Service Bulletin No. 390

MODEL E4500 / J4500 Series Coaches	TYPE Field Change Program	SECTION/GROUP 3 – Body	DATE Aug. 3, 2012
SUBJECT DRAIN HOLES IN DRIVE AXLE SUSPENSION SUPPORT STRUCTURE			
CONDITIONS

Figure 1. Drive axle support structure cross tubes.

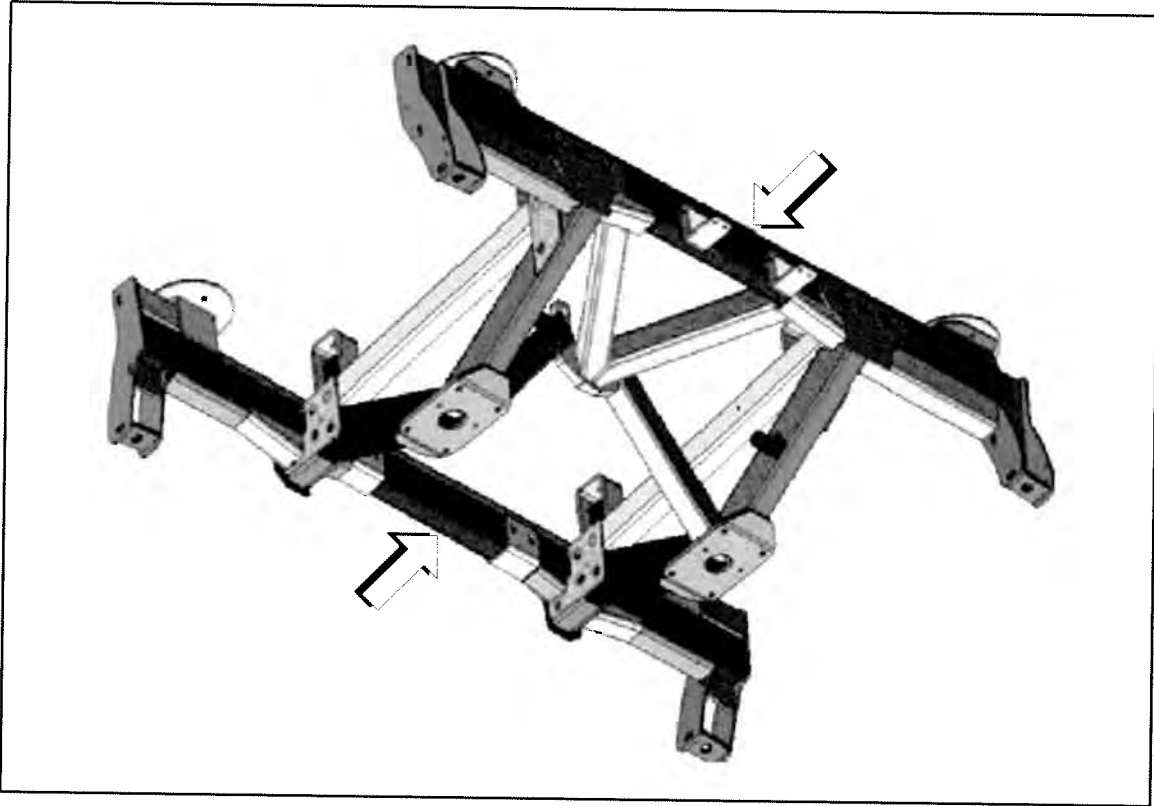
- Using a caliper, measure a clean area of the outside fore–aft dimension on each of the two (2) drive axle support structure cross tubes.

In the event that either of the fore–aft measurements exceeds 3.18 inches, without the presence of rust, dirt or debris, or if a crack is present anywhere on either cross tube, contact the MCI Fleet Support Technical Center at 1-800-241-2947 for further information, before proceeding any further.

Figure 2. Rear of drive suspension support structure.

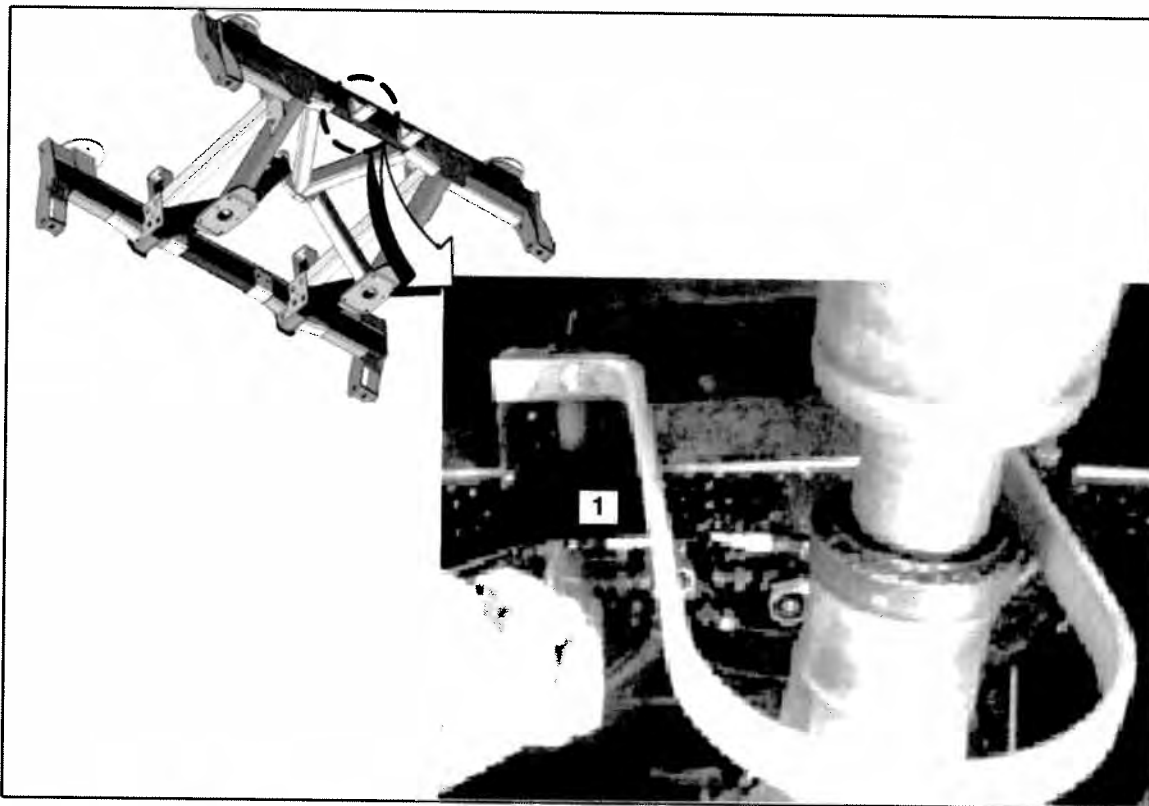
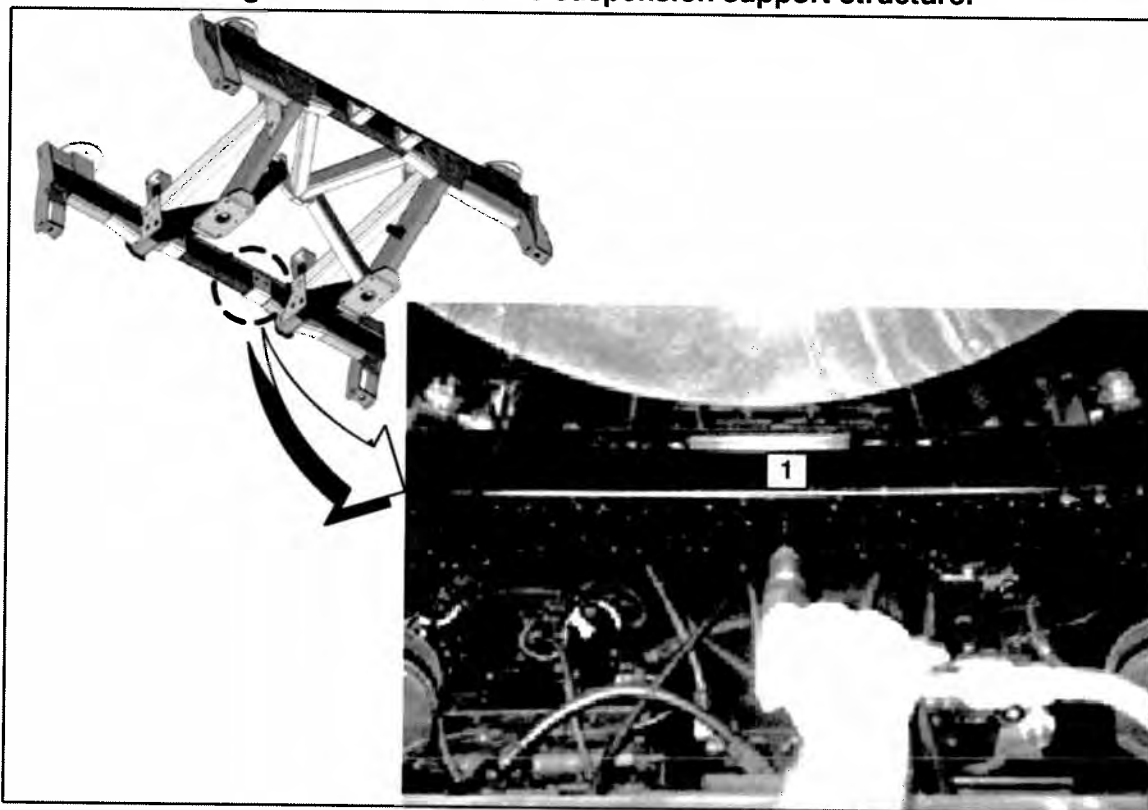
5. With the coach on a lift or over a pit, use a 0.250 inch drill bit to drill a hole in the bottom face of each of the cross tubes as shown in Figures 2 and 3.

ITEM	DESCRIPTION
1	Drill a 0.250 inch hole in the bottom face of the cross-tubes.

Figure 4. Two (2) drain holes drilled in the drive suspension support structure.

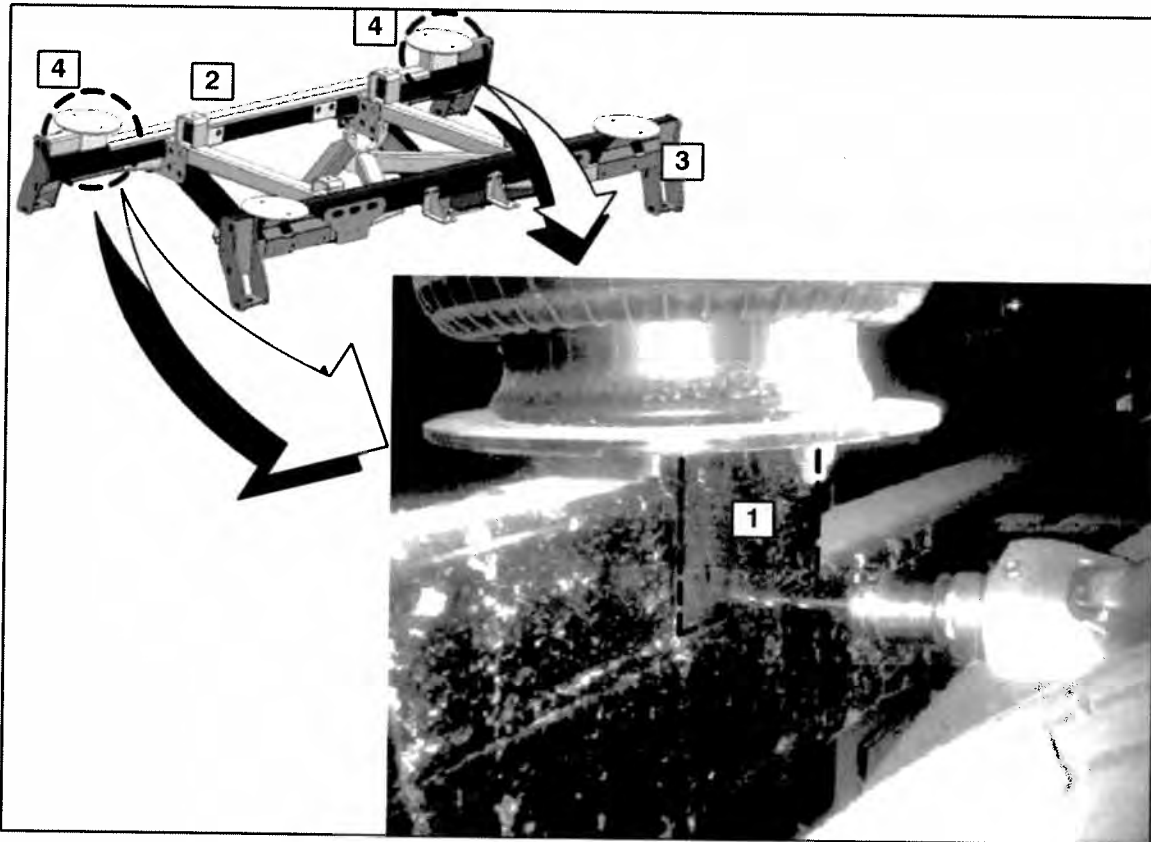
6. With the coach in the High Ride position, use a 0.250 inch drill bit to drill a hole 0.125 inch above the weld, directly underneath the air bag on the vertical face of the tube as shown in Figure 4. Repeat to other side of the tube.

ITEM	DESCRIPTION
1	Drill a 0.250 inch hole 0.125 inch above the weld (in the area shown), directly underneath the air bag on the vertical face of the tube.
2	Front of assembly
3	Rear of assembly
4	Location of the drilled hole
